## FIELD CHANGE NOTICE

78

CMI-40

4 Meg RAM card

DATE		CHECKED BY		REDO		DO BOARD		DRAWING-NO		SHEET-NO		PLOT	
12/1/87								CMI40-05 REV 2.2		5 OF 5		6	
DYNAMIC RAMS												FAIRLIGHT INSTRUMENTS.	
WAVEFORM RAM 2M WORD													
TITLE													
GOLD

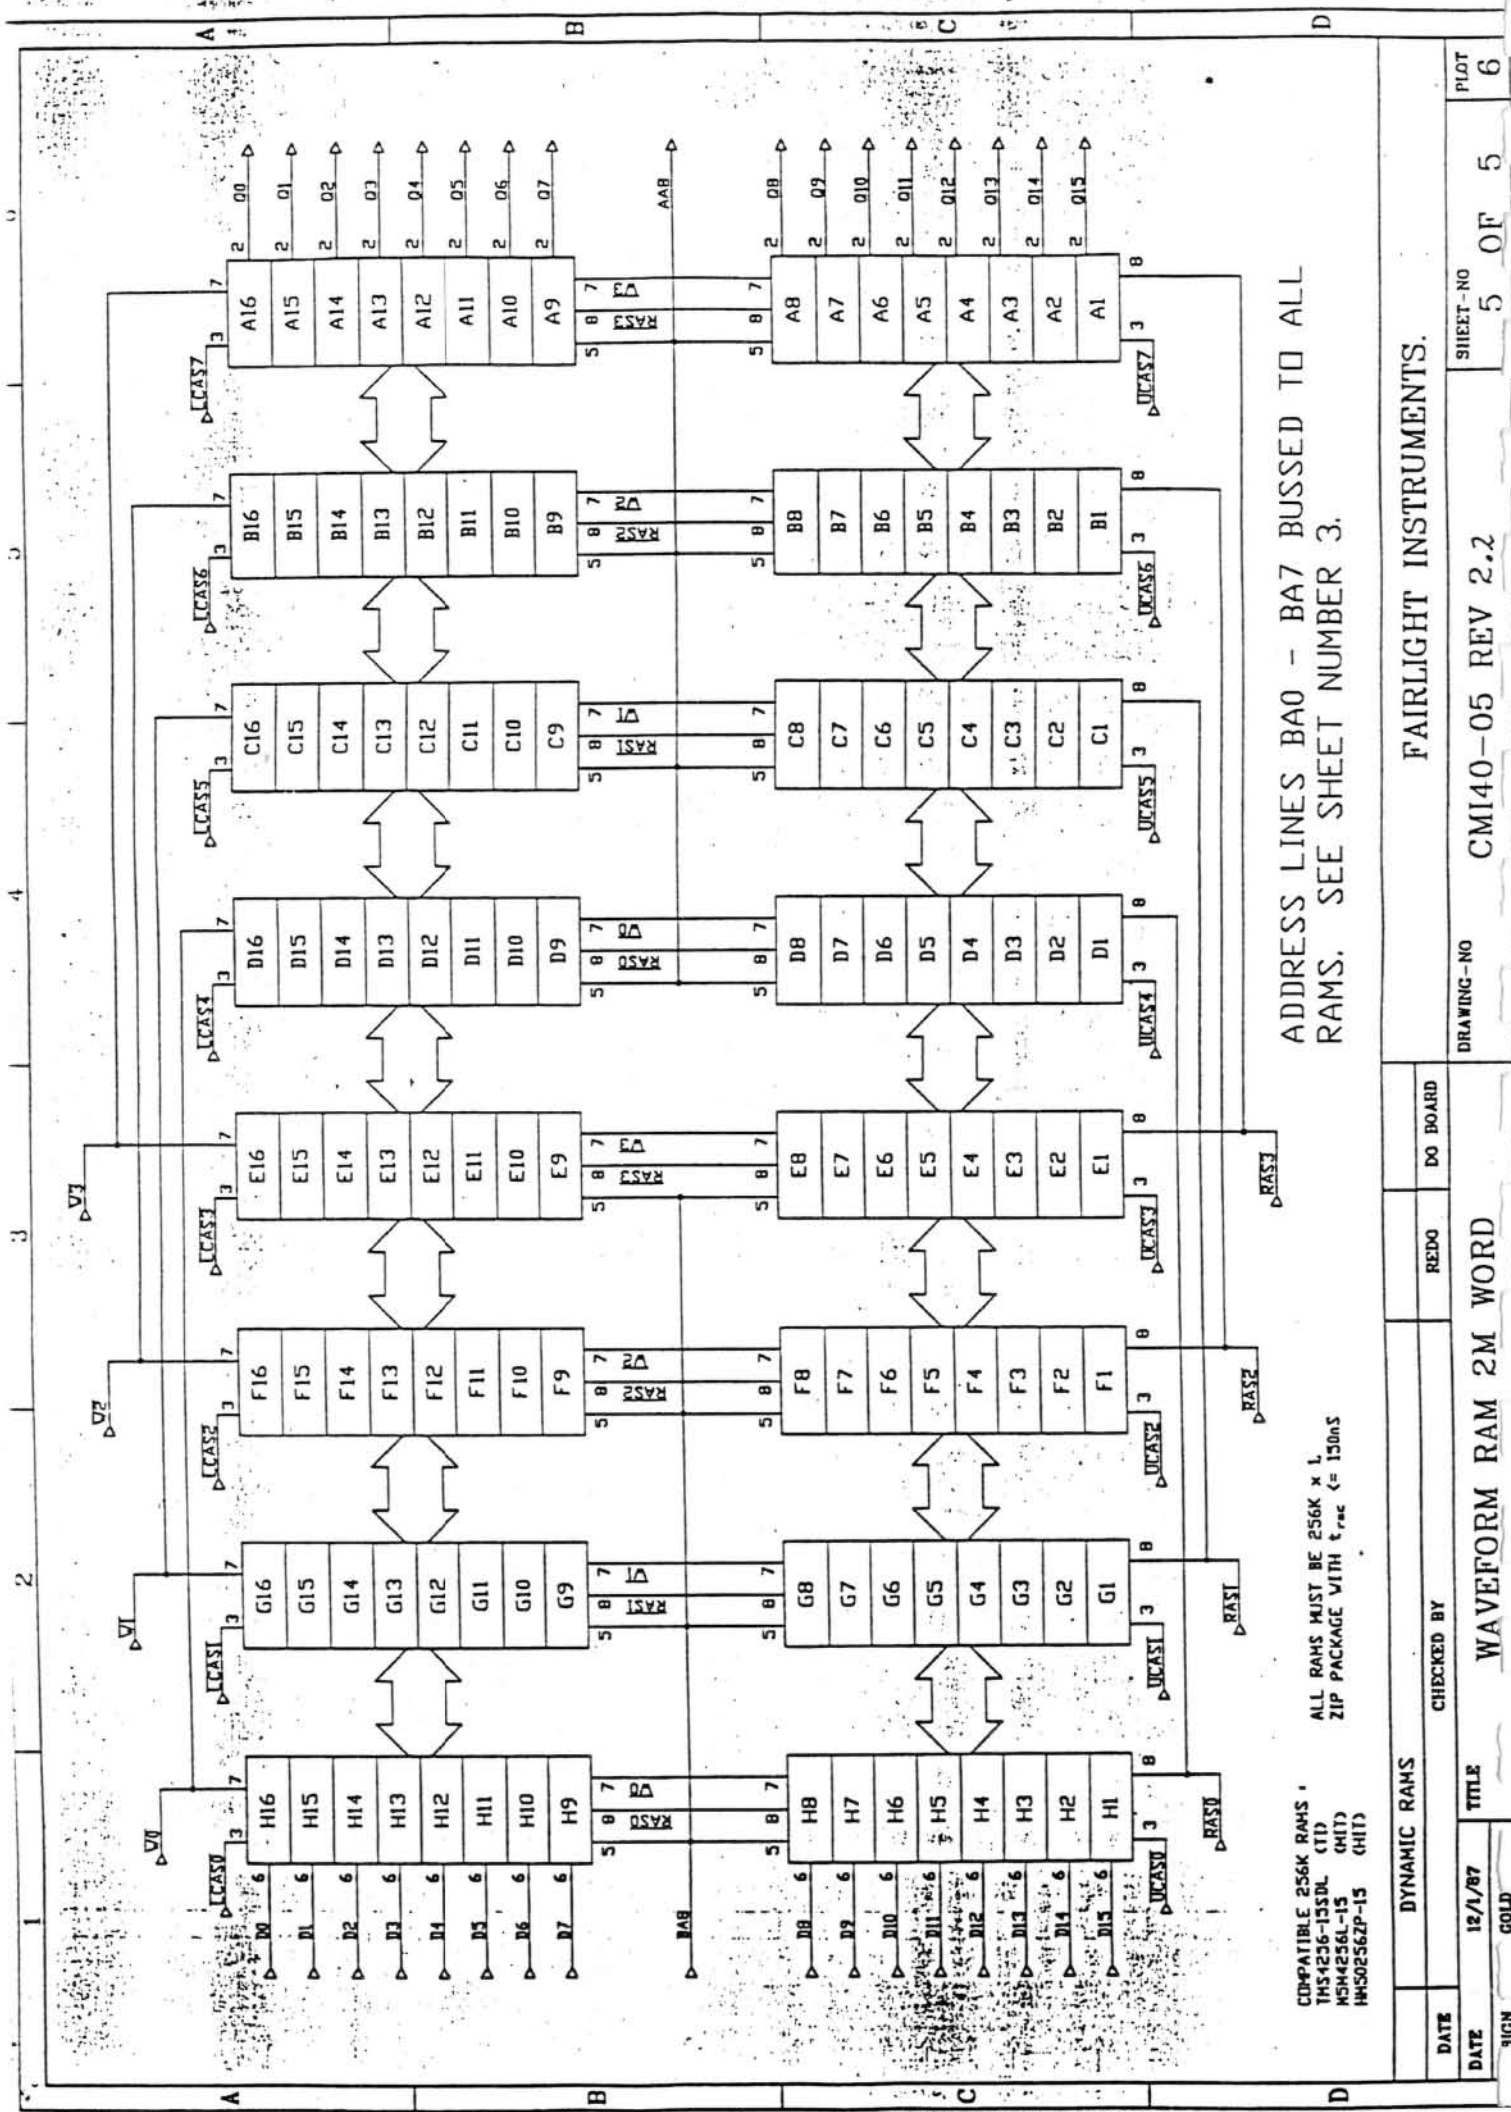
PCB track missing

1. Connect D16 (50256) pin 11 to D15 (50256) pin 11.
